Adv LIGO BSC Flexure Rod Attachment

Proposed re-design

Blade loaded-Sliding flexure in place

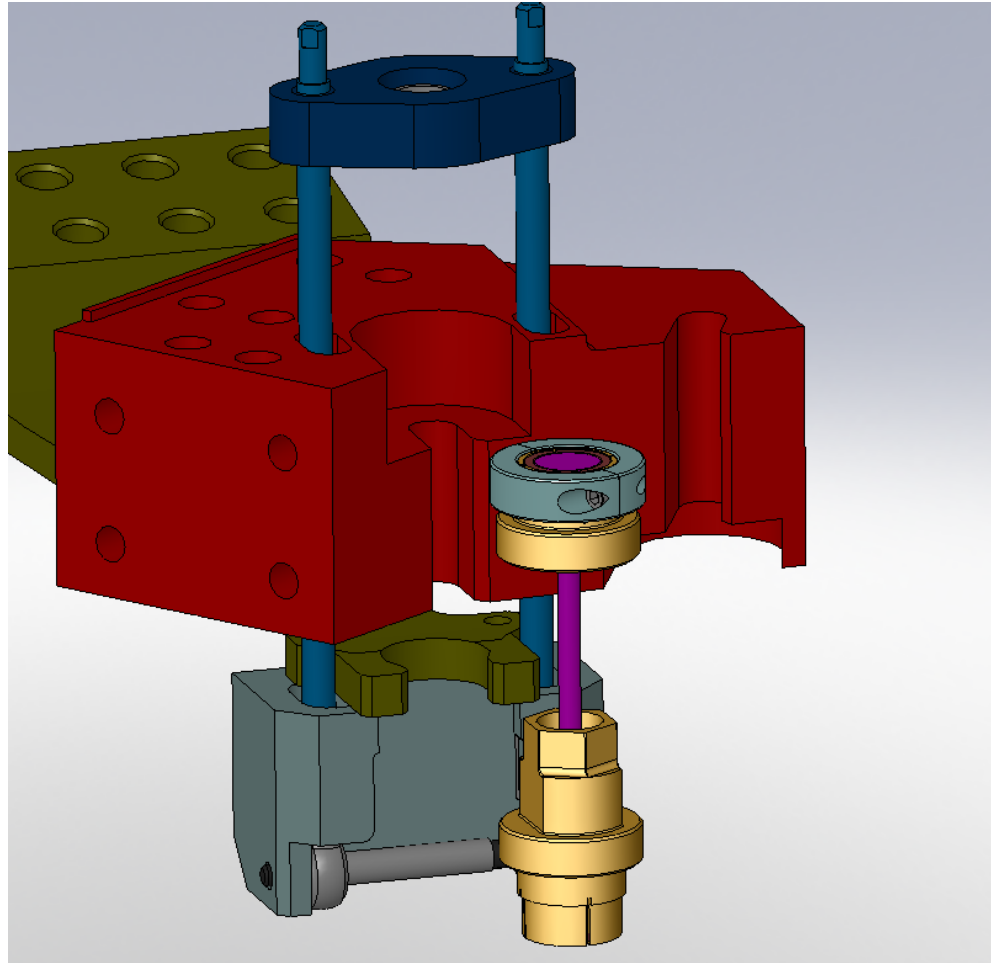
- No attachment or positioning on the bracket side
- Full attachment and positioning on the blade side

Other parts changes

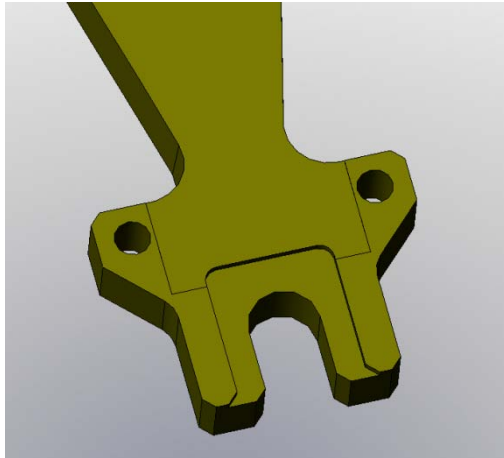
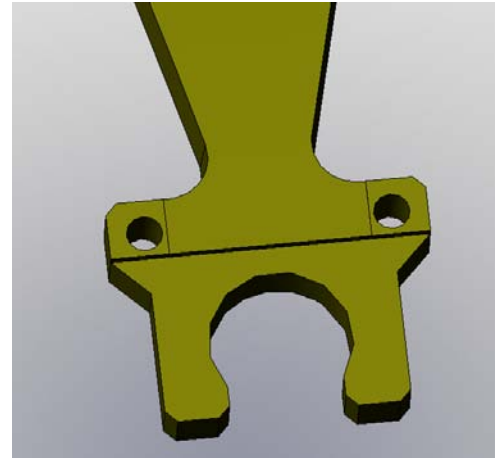
- Blades
 - Enlarged, deeper (.06" to .08") cut-outs
 - Larger slot and hole

Other parts changes (2)

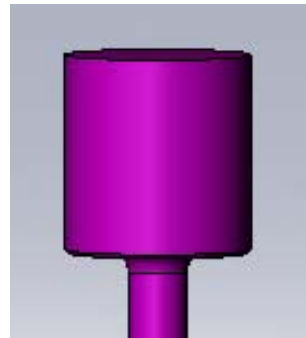
- Bracket
 - Enlarged cut-outs
- Blade loading tool to modify
